ALERT SERVICE BULLETIN

CHECKING OF THE CRANKSHAFT JOURNAL (POWER TAKE OFF SIDE) FOR ROTAX® ENGINE TYPE 912 AND 914 (SERIES)

ASB-912-059

ASB-914-042

Fig. 1
crankshaft journal

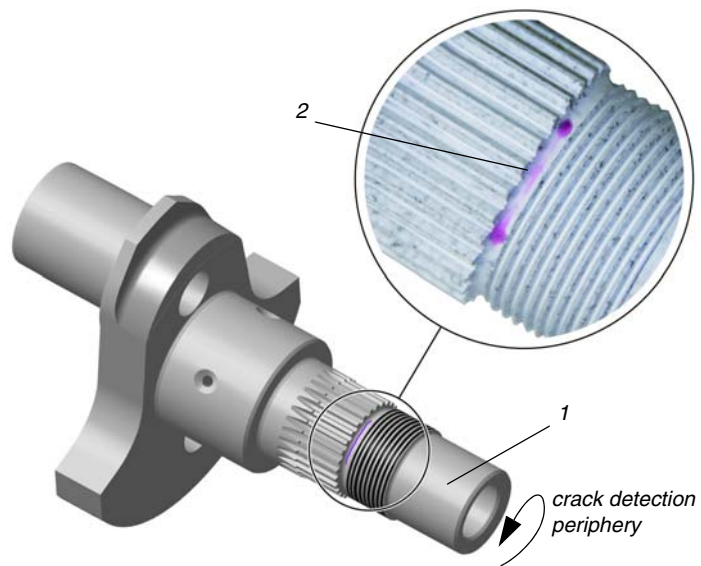
See fig. 1.

6. Unlock the crankshaft to do the check on the entire periphery of the crankshaft.
 - Detailed crack detection in the area (2) of the thread runout using penetration test. Perform this test in accordance to the requirements of the applicable aviation authority in your region for non destructive testing (NDT) and according to DIN EN 571 or equivalent.
